**ADDENDUM NO. 1 TO  
SPECIFICATIONS AND PLANS  
FOR THE CITY OF WIXOM  
WASTEWATER TREATMENT PLANT  
PRELIMINARY TREATMENT SYSTEM IMPROVEMENTS**

**ISSUED:** August 17, 2010

HRC Job No. 20090463

**TREATMENT BLDG. PARTIAL PLAN EL. 921'-6"**

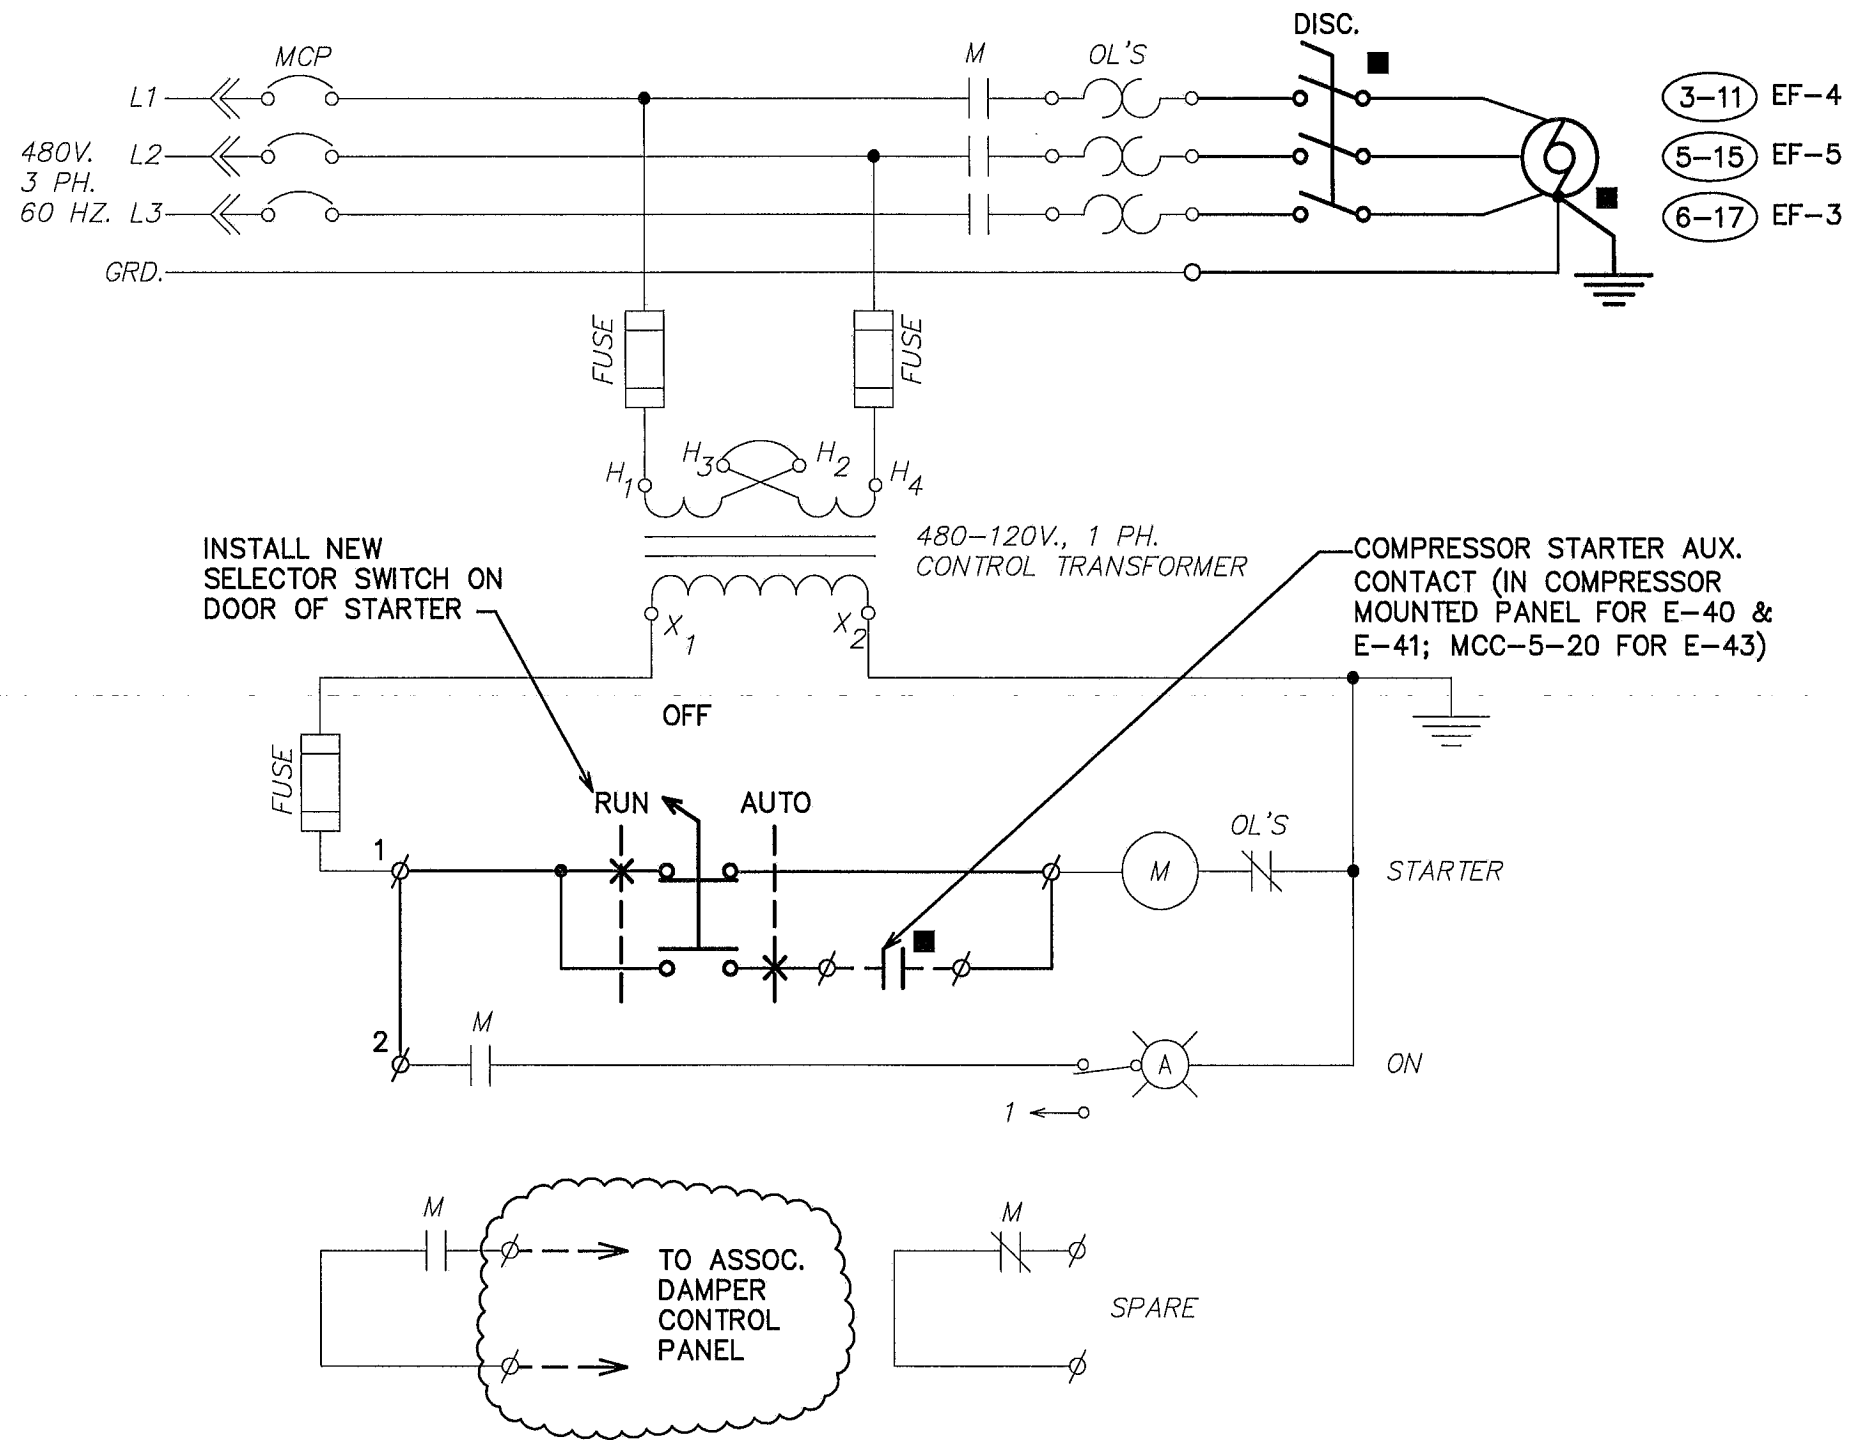
1. Revise the Treatment Building Partial Plan El. 921’-6” as indicated on Sketch SK-E4 issued with this addendum.

1. REMOVE EXISTING AIR DRYER AND ASSOCIATED, WALL-MOUNTED CONTROL PANEL, CONDUIT, AND WIRING. CONNECT NEW AIR DRYER TO EXISTING CIRCUIT, DP-1-13; EXISTING CONDUIT AND WIRING MAY BE REUSED, WHERE PRACTICAL.
2. MOUNT SINGLE RECEPTACLE ON SUPPORT RACK LEG FOR THE COMPRESSOR AUTO-DRAIN. CONNECT BOTH RECEPTACLES TO SPARE 20A, 1 POLE CIRCUIT BREAKER #33 IN EXISTING LP-B.
3. COMPRESSOR E-43 TO BE RELOCATED TO THE SOUTH END OF THE ROOM AS INDICATED. DISCONNECT AND EXTEND THE EXISTING CONDUIT & WIRE (1 1/4" C., 3-#4+1-#6 GRD., +6-#14) TO THE NEW LOCATION, AS REQUIRED.
